Important Notices

TOSHIBA Microcontrollers 900 Family

Restriction on Use of 8-bit Timers

Datasheet Modifications: I²C Bus Mode Control

Example when using PWM mode

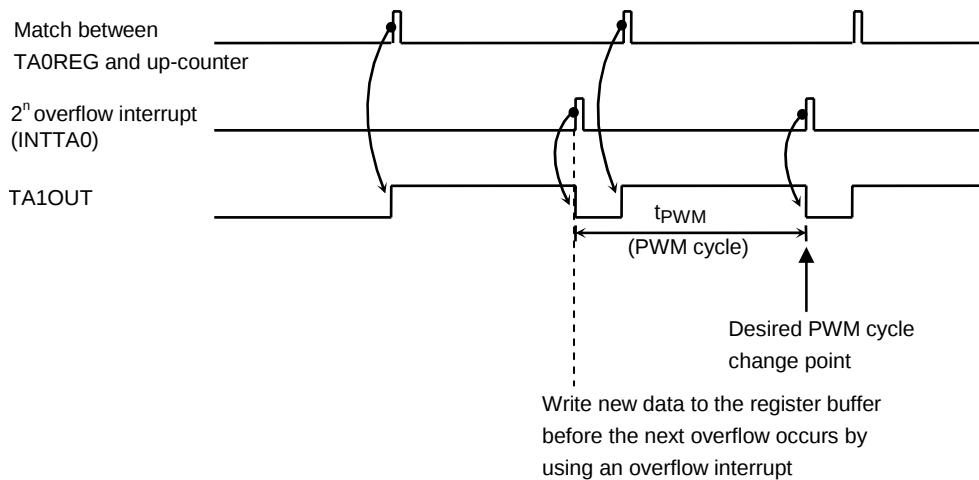
When the double buffer is enabled for an 8-bit timer in PWM or PPG mode, caution is required as explained below.

If new data is written to the register buffer immediately before an overflow occurs by a match between the timer register value and the up-counter value, the timer flip-flop may output an unexpected value.

For this reason, make sure that in PWM mode new data is written to the register buffer by six cycles ($f_{\text{sys}} \times 6$) before the next overflow occurs by using an overflow interrupt.

In the case of using PPG mode, make sure that new data is written to the register buffer by six cycles before the next cycle compare match occurs by using a cycle compare match interrupt.
